Powercor 2026 - 2031 Regulatory Proposal

REVIEW OF ASPECTS OF PROPOSED EXPENDITURE ON AUGEX, REPEX AND VEGETATION MANAGEMENT

Report prepared for:
**AUSTRALIAN ENERGY
REGULATOR (AER)**
August 2025

Figure 3.1: Powercor proposed repex compared with current and historical - \$m, real FY2026²⁴

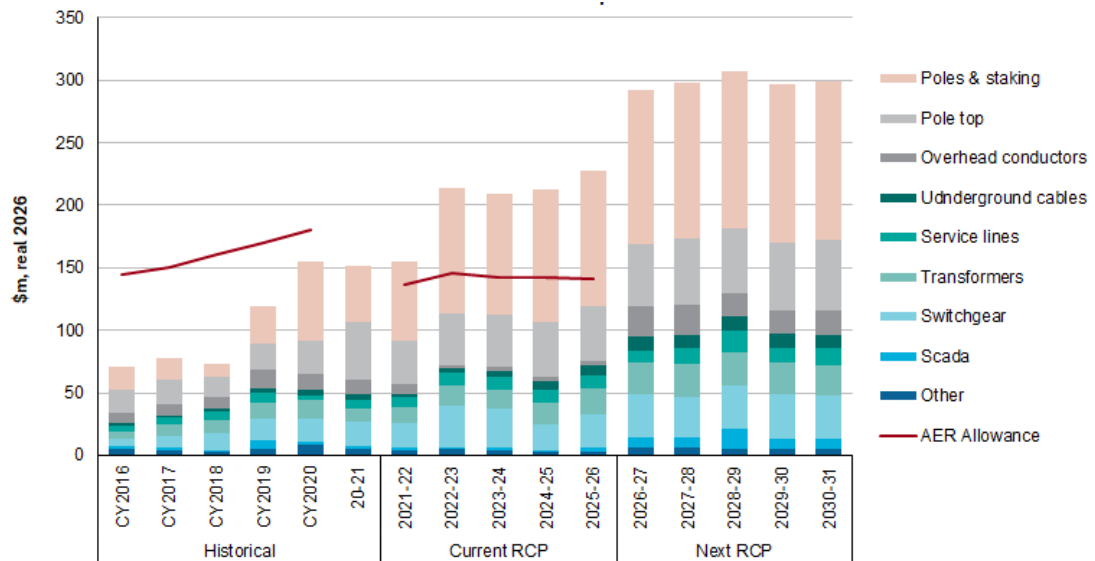
168. As shown in Figure 3.1, Powercor expects to materially overspend its repex compared with the allowance in the current period - particularly for poles and pole-top structures. Powercor explains the overspend as being the result of the following factors:
- rising input costs, and
 - increasing expenditure consistent with a longer-term trend of increasing asset replacements of high-volume distribution assets, which is reflective of the characteristics of the underlying asset populations.
169. We looked for evidence of the rising input costs, and the impact on Powercor relative to other DNSPs. In terms of increasing expenditure requirements, we are guided by the requirement of the NER, specifically to assess whether the proposed increases are prudent and efficient, and justified as economic.

Figure 3.2: Comparison of average annual repex across regulatory periods - \$m, real FY2026

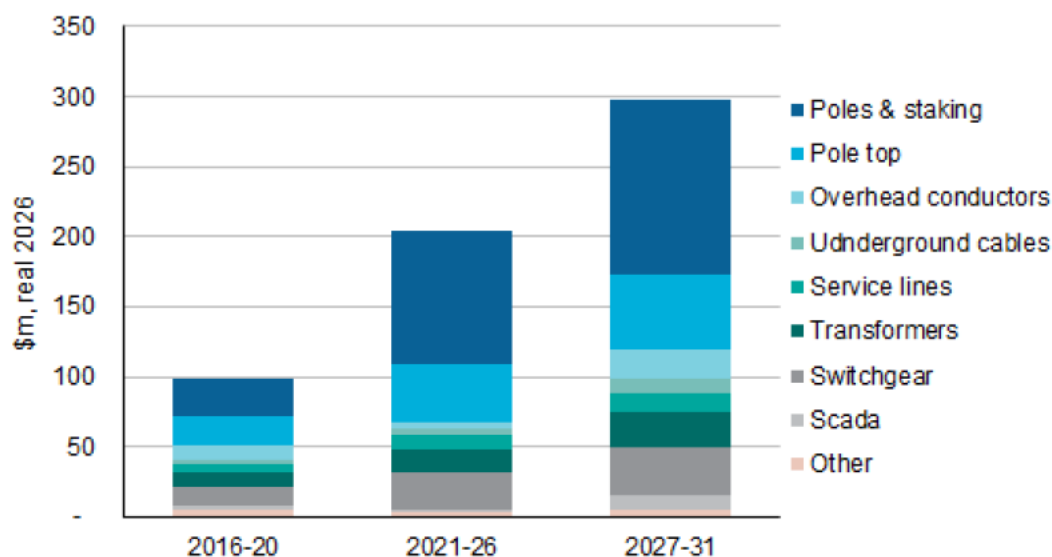
171. As shown in Figure 3.1 and Figure 3.2, there has been a step increase in repex across the last two regulatory periods, and which applies to most asset groups. The largest increases are associated with the switchgear and underground cables asset groups.

Figure 3.4: Historical and forecast pole intervention volumes²⁹

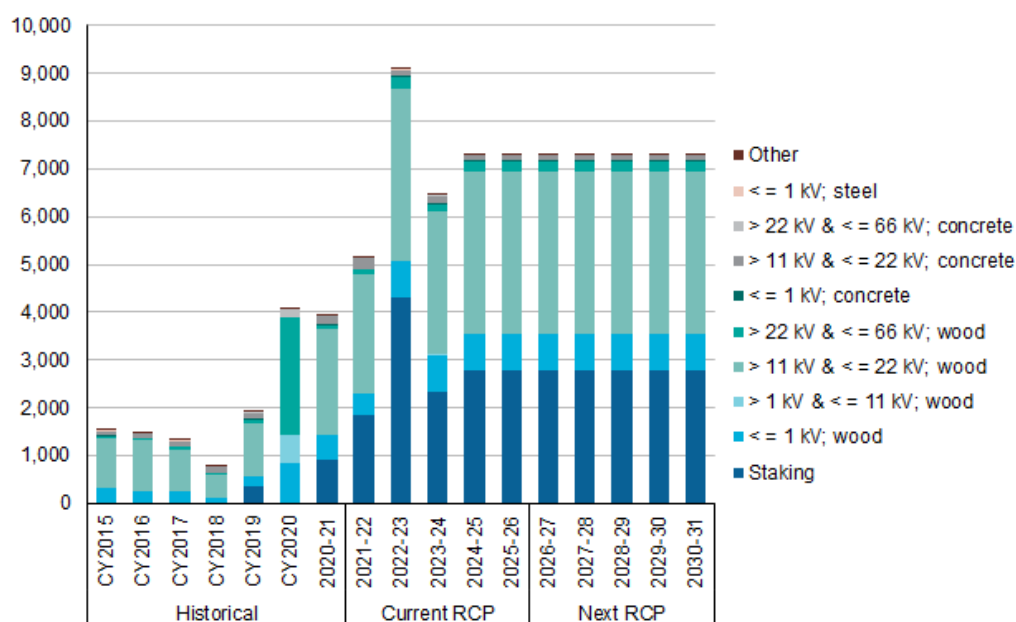
180. The proposed historical and forecast intervention volumes are shown in Figure 3.4. We observe a large spike in intervention volumes in 2022-23, which we understand is associated with implementing the increase in pole interventions arising from the ESV direction to treat a higher volume of poles.
181. The spike in 2022-23 is largely driven by increases in pole staking volumes as shown in Figure 3.3.

Figure 3.7: Recent actual LV wood pole replacement unit cost, \$ FY2026

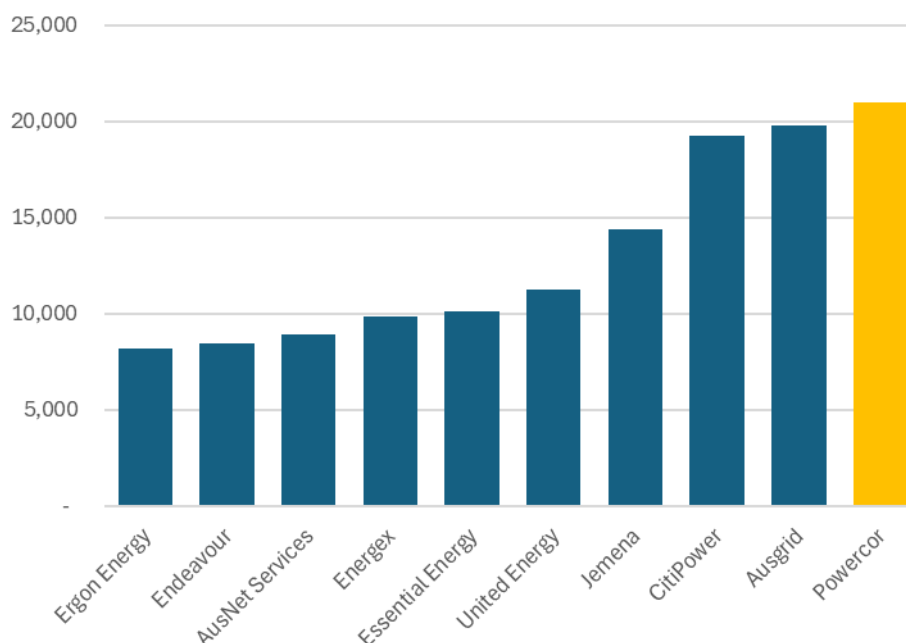
208. In Figure 3.7 we show the most recent actual cost for LV pole replacement recorded in the RIN. Powercor is shown to have incurred the highest cost, above DNSPs which may be subject to additional costs associated with inner urban/CBD locations including CitiPower and Ausgrid. Powercor was not able to explain to us the reasons for its much higher unit costs than comparable DNSPs.

Figure 3.8: Volume weighted 1kV, 11kV and 22kV wood pole replacement unit cost, \$ FY2026

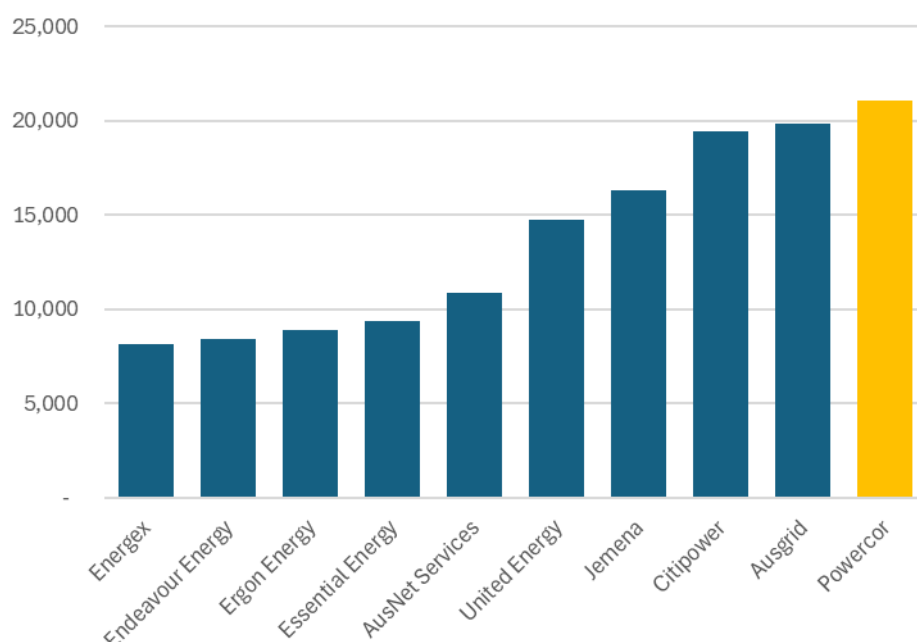
209. In Figure 3.8, we generated a volume weighted wood pole unit cost (comprising 1kV, 11kV and 22kV wood poles replacements) based on the most recent 2024 actual costs. Whilst the order of some DNSPs were interchanged, the DNSPs incurring the highest unit costs did not, with the highest being Powercor.

Figure 3.9: Historical LV pole replacement unit rate - \$ FY2026

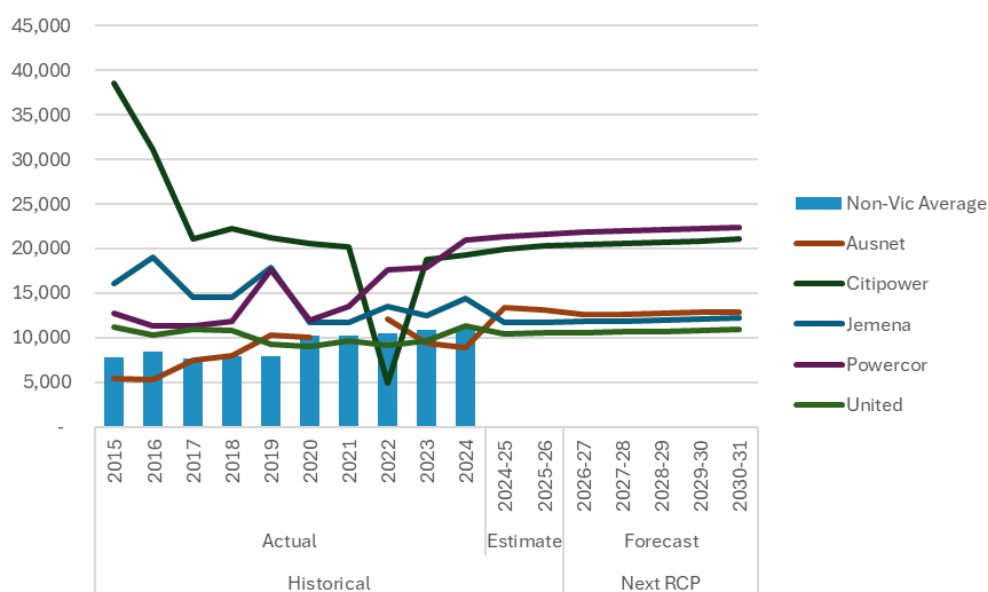
210. The unit rates reported by Powercor are materially above those being incurred by other DNSPs and cannot be considered as reflective of an efficient cost. We accept that more recent cost increases may increase costs above historical trends, however this should be evident in the costs of other DNSPs both in Victoria and across the NEM. Rather it appears that Powercor and CitiPower have higher historical costs, and which may reflect higher cost structures, and which are reflected in higher forecast costs.
211. In Figure 3.9, we show the historical unit rate for a LV wood pole for Victorian DNSPs using information from the RIN to understand whether there were any common factors contributing to the cost.

Figure 3.12: Trend of defects and failures for crossarms

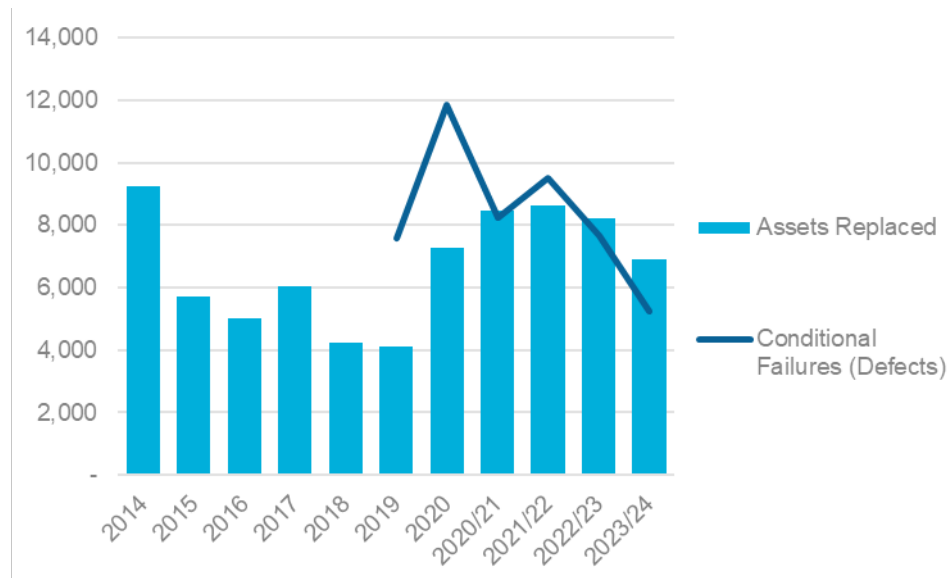
230. The defects and failure information provided by Powercor indicates a declining trend. We show the declining defects in Figure 3.12 with a similar downward trend observed in unassisted failures.

Figure 3.13: Historical LV crossarm replacement unit rate - \$ FY2026

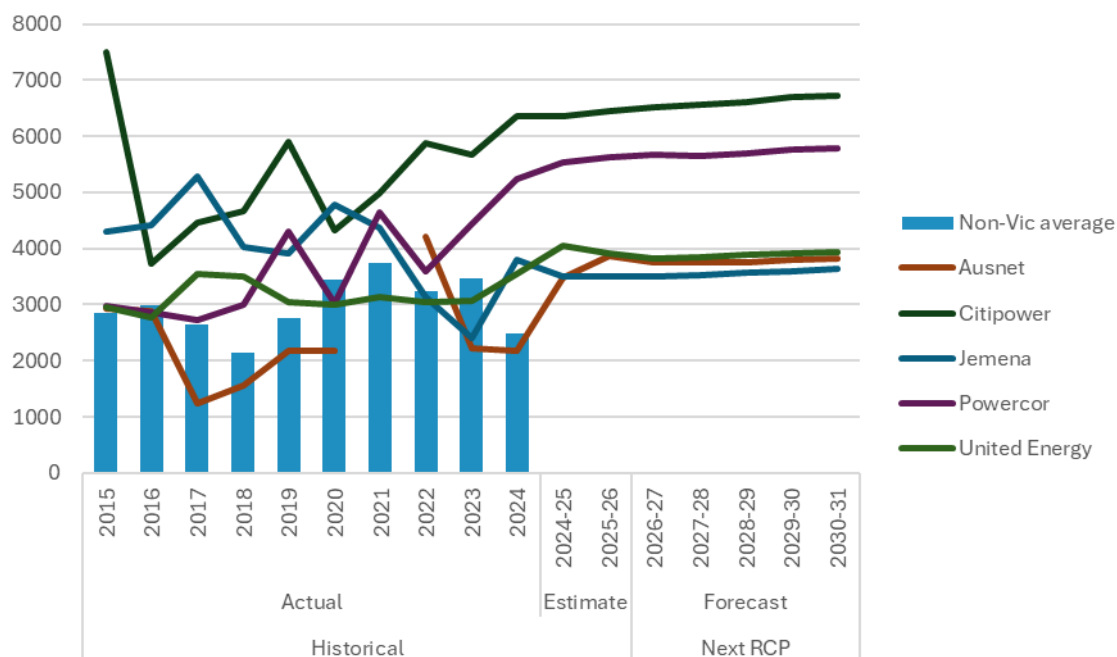
241. In Figure 3.13, we show the historical unit rate for a LV crossarm replacement for Victorian DNSPs compared with the average across non-Victorian DNSPs using information from the RIN to understand whether there were any common factors contributing to the cost.

Figure 3.16: Historical conductor replacement volume

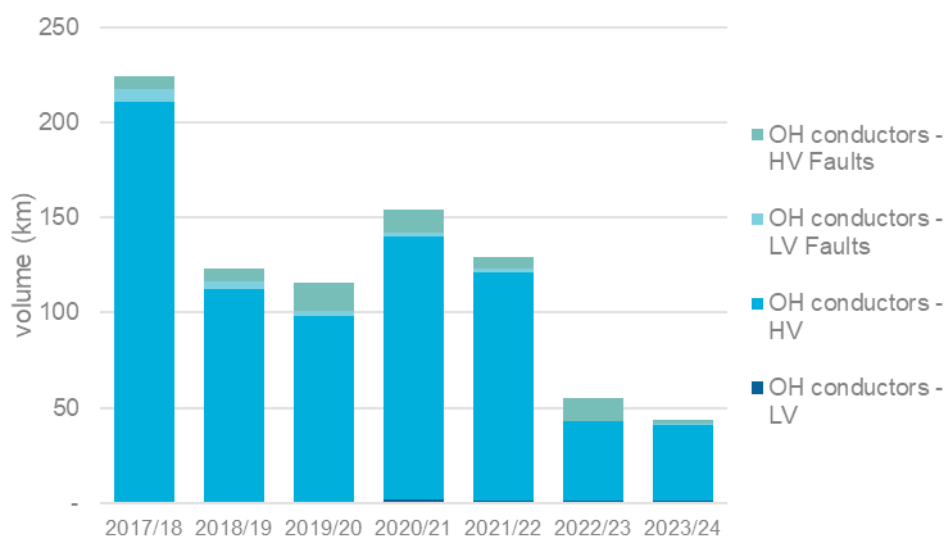
264. We show the historical replacement data relied upon by Powercor in Figure 3.16. We consider that the more recent 5-year actual data is more reflective of Powercor's current replacement volume, and more likely to reflect the network performance.

Figure 3.17: Historical fire starts by voltage

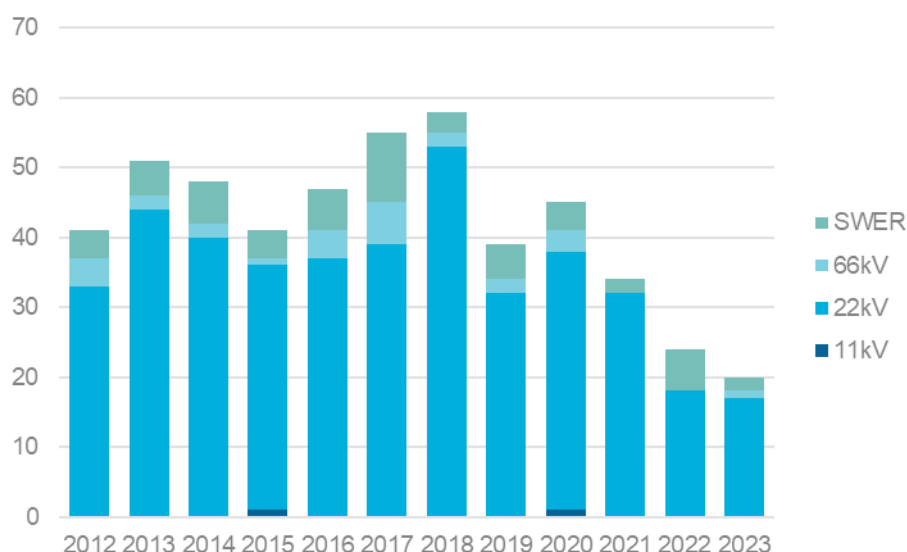
327. Powercor states that 22kV lines are the leading cause of HV conductor fire incidents, accounting for 83 per cent of all HV conductor-related fires. We asked Powercor for the data that supports the statements around fire starts. Whilst the response confirmed that fire starts are dominated by 22kV voltage lines, the number of fire starts has been declining since 2020 as shown in Figure 3.17.

Figure 3.20: Example of the risk cost stack for WBL substation (\$2023)

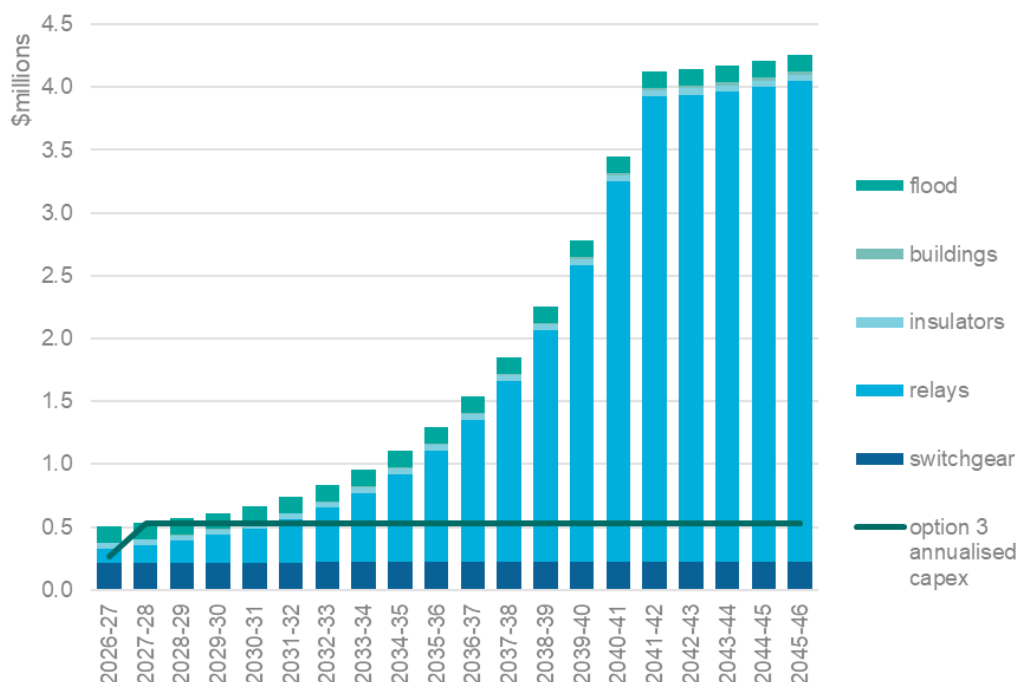
406. The largest source of risk is associated with its relays, as a hard-coded input from its relay model. We were not able to review the calculation of the relay risks. A sample of Powercor's forecast for the risk cost stack for WBL substation is provided in Figure 3.20.

Figure 3.23: Targeted relay replacements indicated by TRUE, versus future (2034) HI value

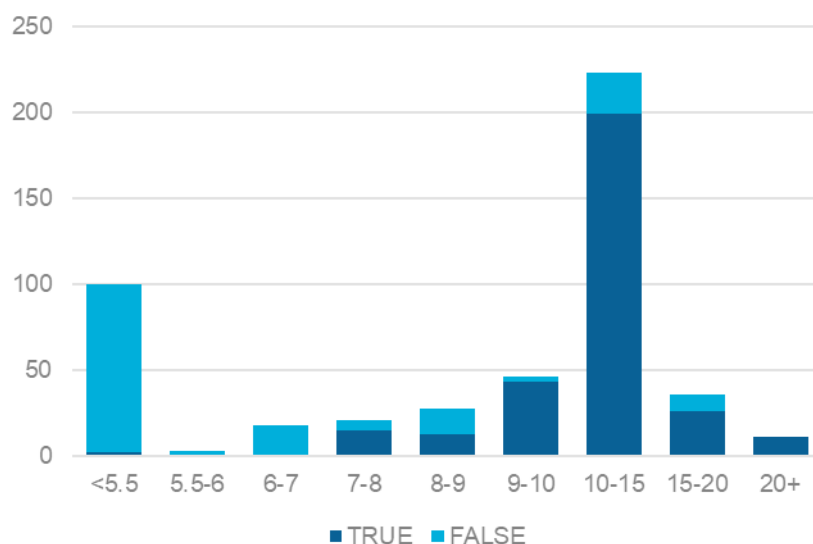
436. When we compare the current and future HI values determined from its CBRM models, we observe that there is significant increase in HI over this period as shown in Figure 3.23, with the largest population of relays in the HI range of 10-15, and a proportion of these not targeted for replacement. Powercor does not explain the relationship between HI values and replacement decisions.

Figure 5.5: Powercor - historical completion volumes

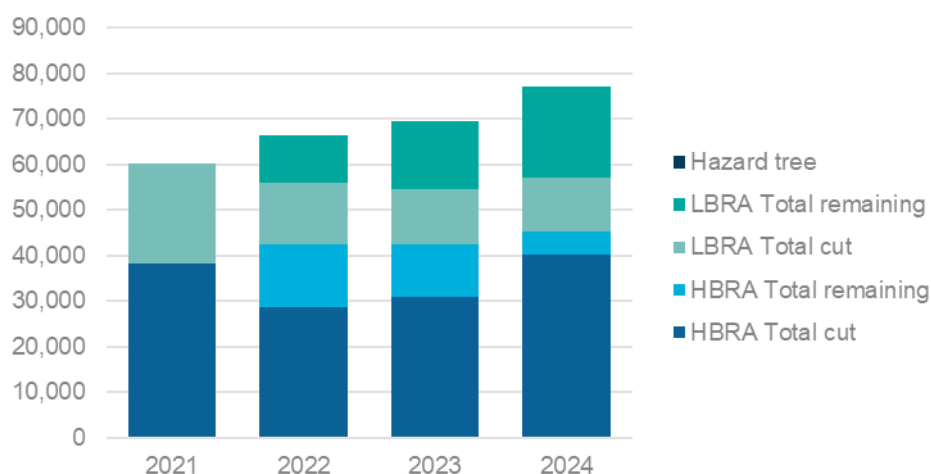
768. In response to our request for information, CPU provided data of its vegetation program for each of the businesses. In Figure 5.5 we have separated the data into Powercor's

completed cutting (HBRA and LBRA), hazard trees. and remaining. In this way we can see the total volume of work identified for Powercor's network.

Figure 5.6: Volume of HBRA spans over the period 2022 to 2024

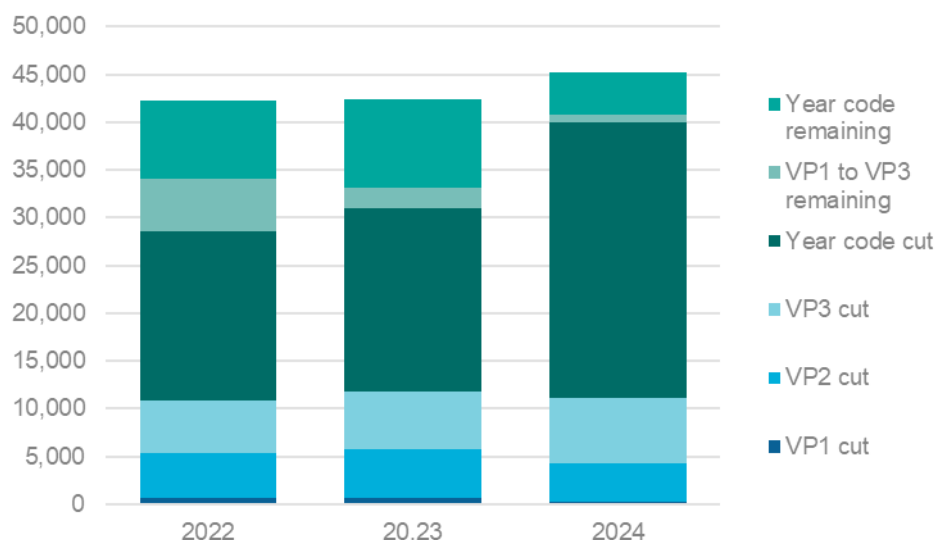
774. As discussed previously, we would expect VP rectification cuts to decrease over time once compliance has been achieved.
775. In Figure 5.6 we illustrate the impact of Powercor's priority focus on vegetation management in the HBRA region, which shows that whilst the maintenance cutting (year code cutting) has increased over this time, the number of spans requiring VP rectification cutting has not.

Figure 5.7: Trend of average vegetation management unit rates - \$, FY2026

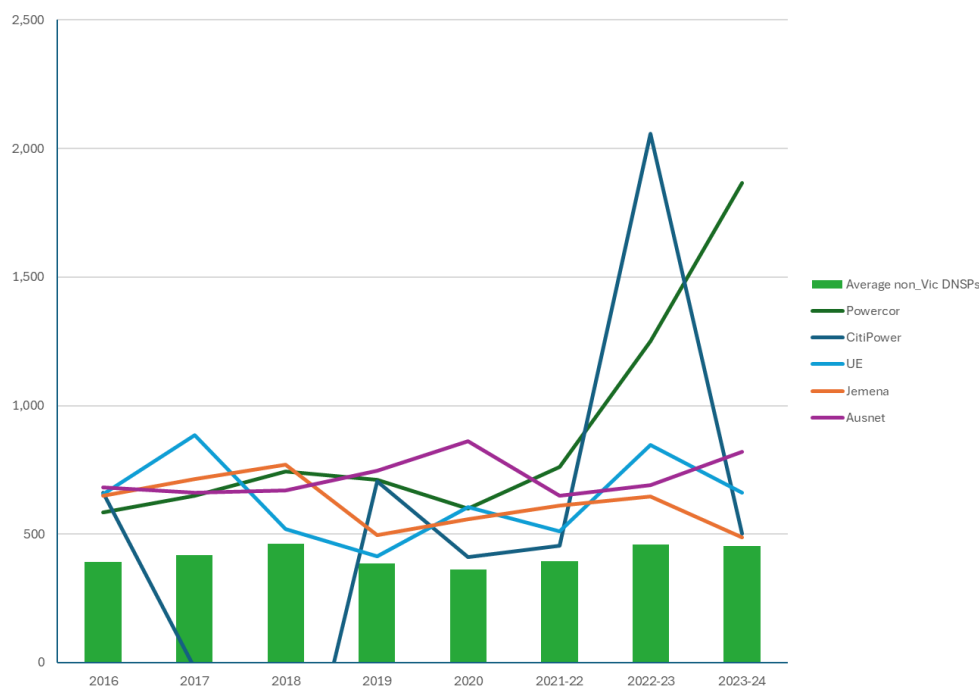
782. We considered unit rates over time, as shown in Figure 5.7, and observe that the Victorian DNSP unit rates are largely flat in real terms, with the exception of Powercor and CitiPower, which both increased from 2021-22 with CitiPower subsequently reducing to previous levels in 2023-24. The negative amounts are not explained by CitiPower.

Figure 5.11: Comparison of 3-year vegetation management unit rates (FY22-FY24) - \$, FY2026

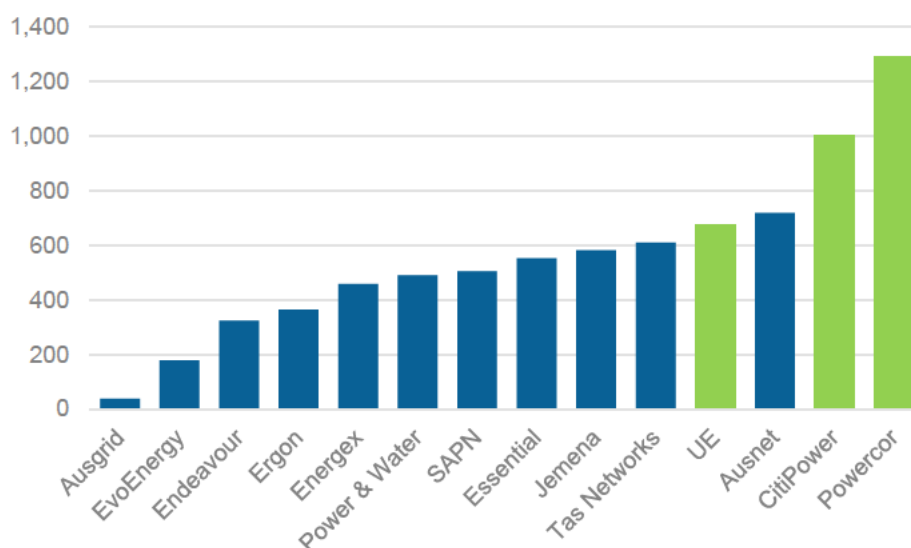
795. Using the same three-year averages, we see in Figure 5.11 that Powercor and CitiPower have the highest historical unit rates.

Figure 5.12: Proportion of LiDAR costs – Powercor and CitiPower, \$m FY2026

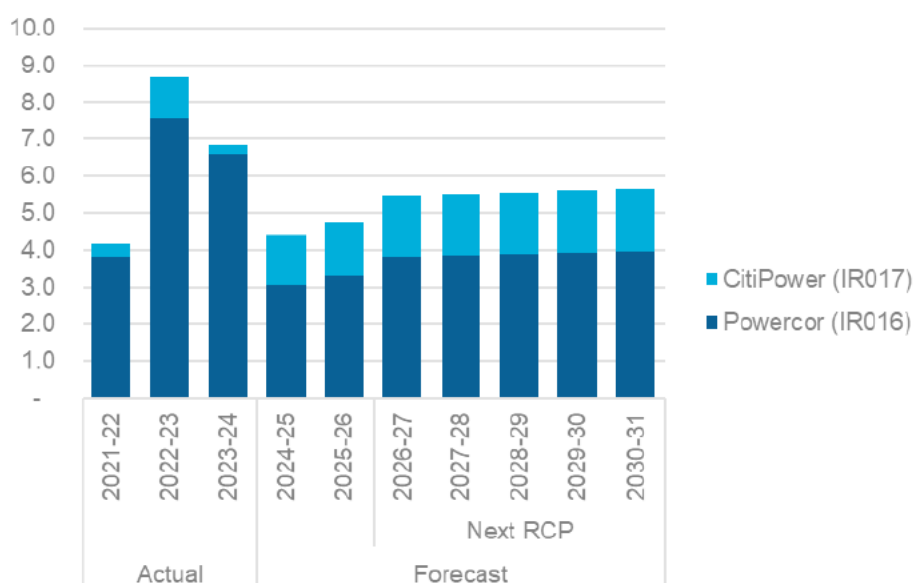
803. We were made aware that CPU had changed the allocation of its shared LiDAR costs between CitiPower and Powercor, such that Powercor has been allocated a lower percentage of the shared LiDAR costs. In Figure 5.12 we show the LiDAR costs over time for CitiPower and Powercor, and can see that the allocation has changed, and that the change was made in 2024-25 which Powercor is claiming as its base year. We also note that Powercor has reduced its LiDAR costs relative to its historical costs.
